<b>File Number</b>	PL 22-122	<b>Contact</b>	Chris Lee, clee@duluthmn.gov	
<b>Type</b>	MU-I Planning Review: Accessory Parking Lot	<b>Planning Commission Date</b>		August 9, 2022
<b>Deadline for Action</b>	<b>Application Date</b>	July 6, 2022	<b>60 Days</b>	September 4, 2022
	<b>Date Extension Letter Mailed</b>	July 15, 2022	<b>120 Days</b>	November 2, 2022
<b>Location of Subject</b>		916 East 3 <sup>rd</sup> Street		
<b>Applicant</b>	Jefferson School, LLC	<b>Contact</b>	Christian Murphy	
<b>Agent</b>	Northland Consulting Engineers	<b>Contact</b>		
<b>Legal Description</b>		See attached, PIN: 010-3830-07680, 010-3830-07692		
<b>Site Visit Date</b>		July 25, 2022	<b>Sign Notice Date</b>	July 26, 2022
<b>Neighbor Letter Date</b>		July 26, 2022	<b>Number of Letters Sent</b>	63

**Proposal**

PL22-122  
MU-I Planning Review  
916 E 3rd St

Jefferson Square Apartments

**L1.0**  
SITE LANDSCAPE  
PLAN

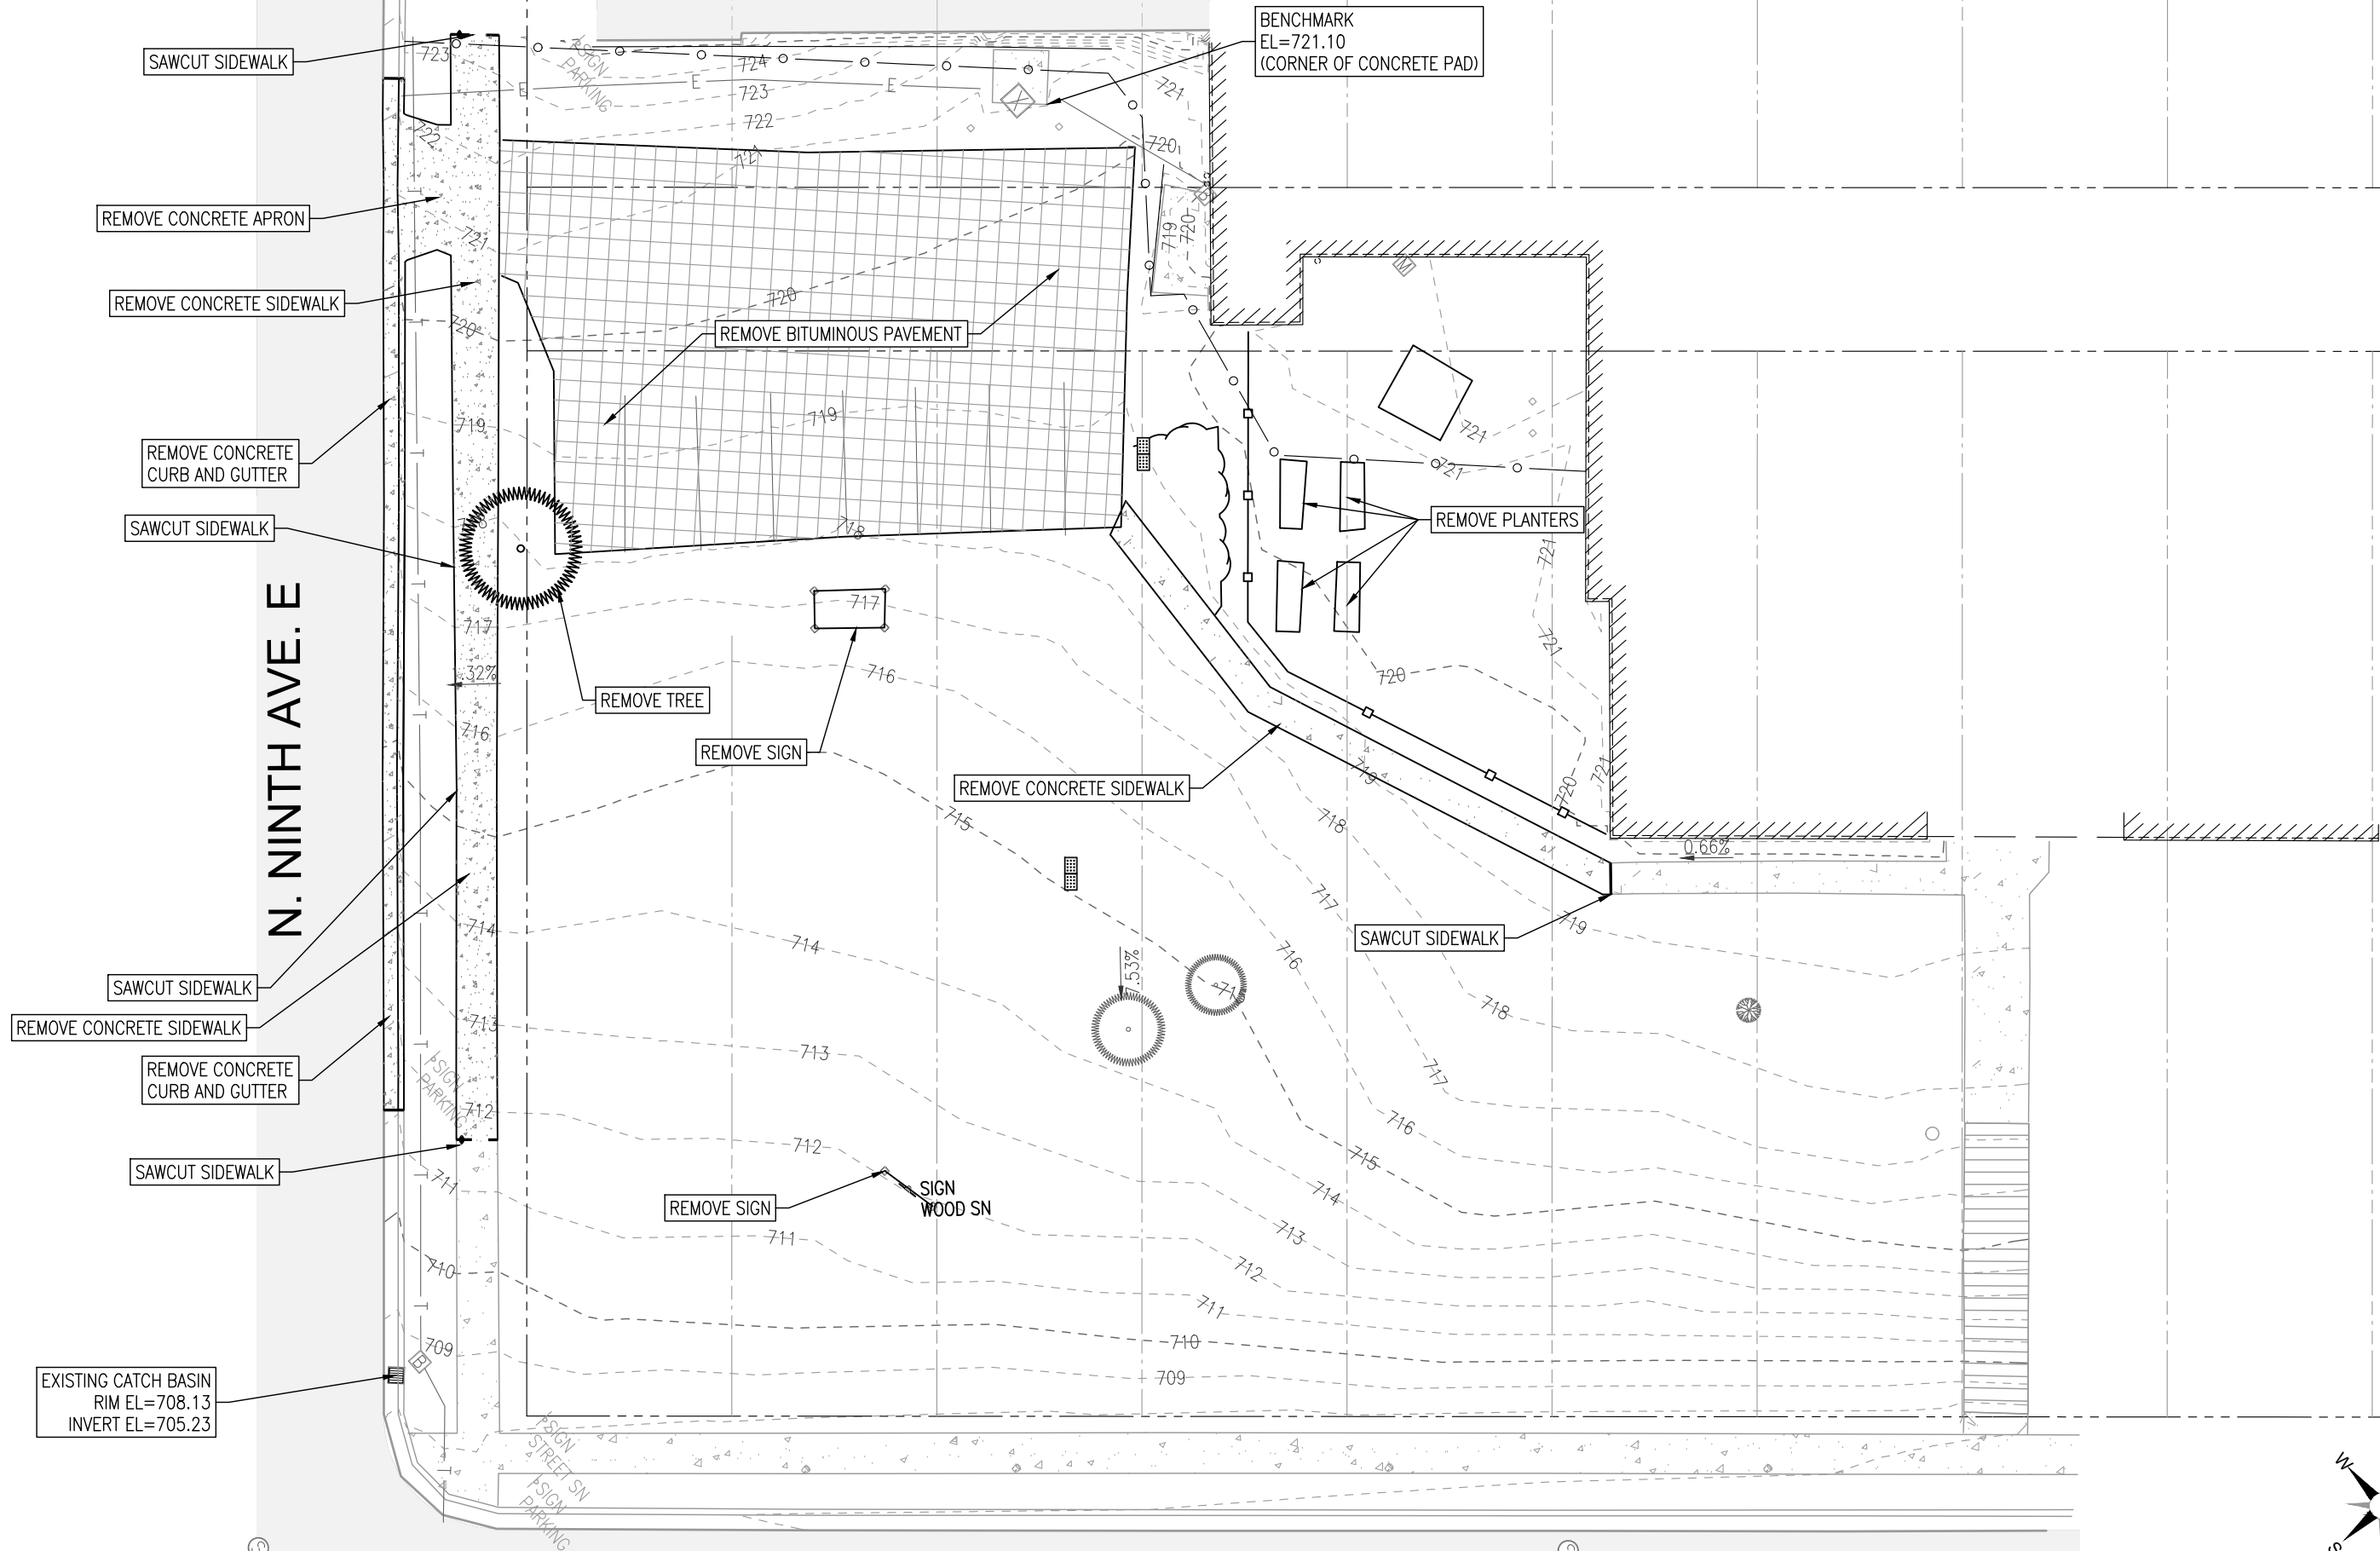
- 5) 50-25 (Landscaping) – The landscape plan indicates 4 new maples trees for the required parking lot coverage, along with 16 new shrubs that comply with UDC requirements. The applicant will be removing 3 trees as part of the construction.
